DART AEROSPACE LTD		Work Order:	102562
Description: Bar		Part Number:	D3196-4
Inspection Dwg: D3196 Rev: C		Page 1 of 1

DRAWING NO. D3196	TITLE BAR	REV. C	DART AEROSPACE LTD ENGINEERING ORDER		D.E.O. NO. D3196-C-1	SHEET NO. SHEET 1 OF 2	SCALE NTS
DRAWN AJS	CHECKED	MFG. APPR.	APPROVED		DE APPR.		
DATE 08.08.27	DATE 08.08.28	DATE 08.08.29	DATE 08.08.29		DATE 08.09.04

SHEET 1 MODIFY SLOT DIMENSIONING ON D3196-1 AS SHOWN:

D3196-3 BAR

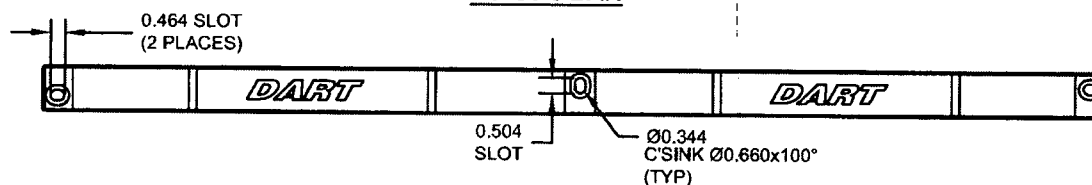
SHEET 2 MODIFY SLOT DIMENSIONING ON D3196-3 AS SHOWN:

D3196-4 BAR

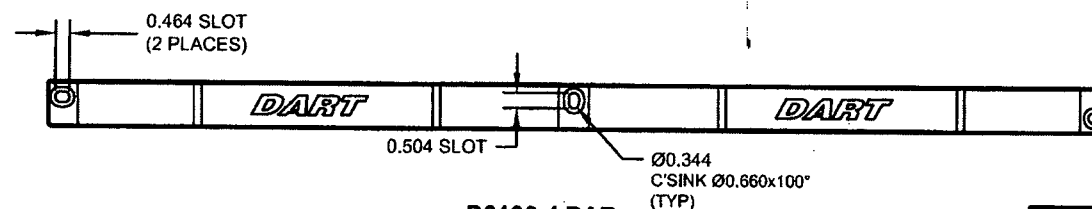
SHEET 3 MODIFY SLOT DIMENSIONING ON D3196-4 AS SHOWN:

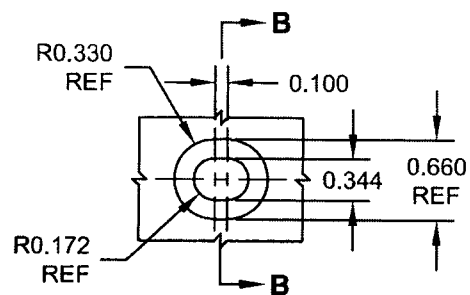
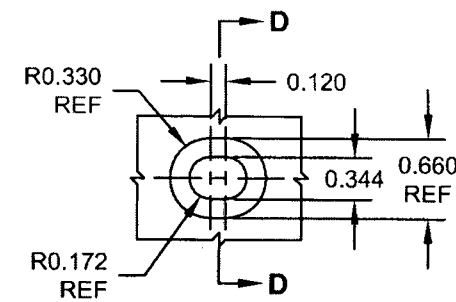
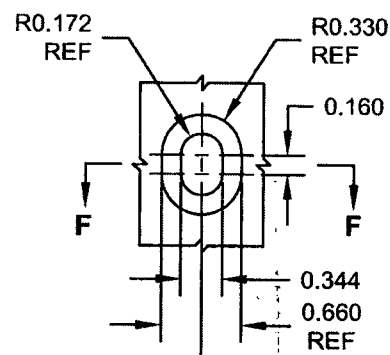
NOTE: THIS CHANGE HAS BEEN DONE TO CLARIFY SLOT DIMENSIONS ONLY. NO CHANGES HAVE BEEN MADE TO THE PARTS
SEE NCR 08-051 FOR FURTHER INFORMATION
ALL OTHER INFORMATION REMAINS UNCHANGED
